Department of Environmental Quality

February 26, 2008

RE: Review of Septic Tank Specifications for Inclusion or Non-inclusion on the:
Wyoming APPROVED SEPTIC TANK List

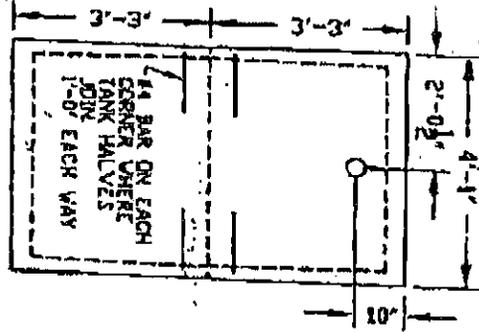
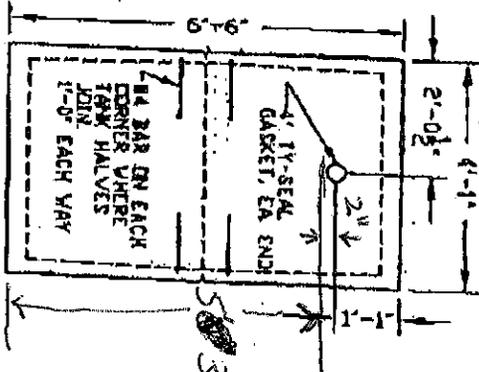
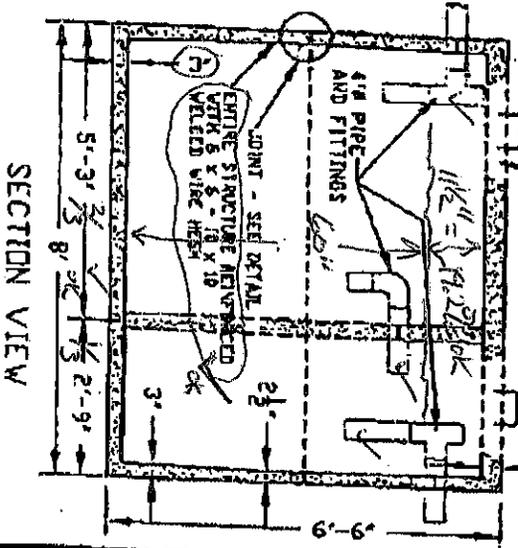
- 1000 gallon, Single compartment concrete septic tank,
- 1000 gallon, Two compartment concrete septic tank, and
- 1500 gallon, Two compartment concrete septic tank.

Please note that the "A-List" of the approved list contains the following requirement for all tanks, "Septic Tank Clean-Out Riser Requirement - Either a 6-inch diameter clean-out riser or the manway from each compartment of the septic tank must be extended to the ground surface from all septic tanks."

CONCRETE OIL & SAND OR
 GREASE INTERCEPTOR, 1000 GAL. CAP.

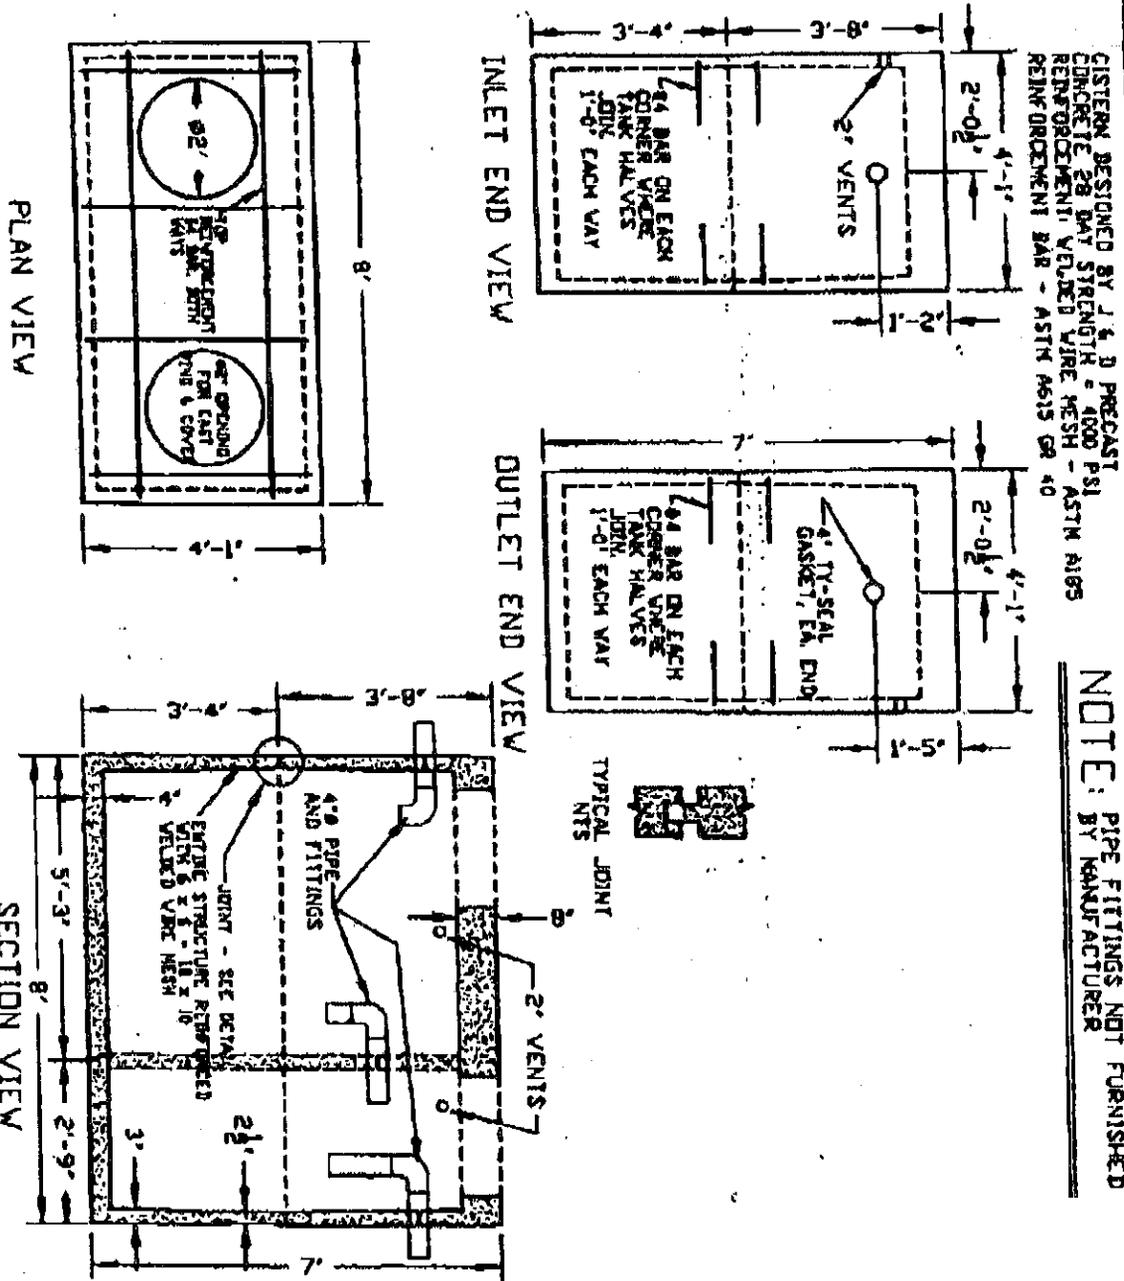
J&D Precast also submitted 1000 & 1500 gallon grease interceptor tanks for review. The WQD does not pre-approve grease interceptors or have a list of approved grease interceptor tanks as it does for septic tanks. However, without a detailed review, it appears that these tanks could probably (emphasize PROBABLY) be used as grease interceptors if plumbed and baffled in the correct way.

*Per -
 If possible
 look for
 the
 tank*
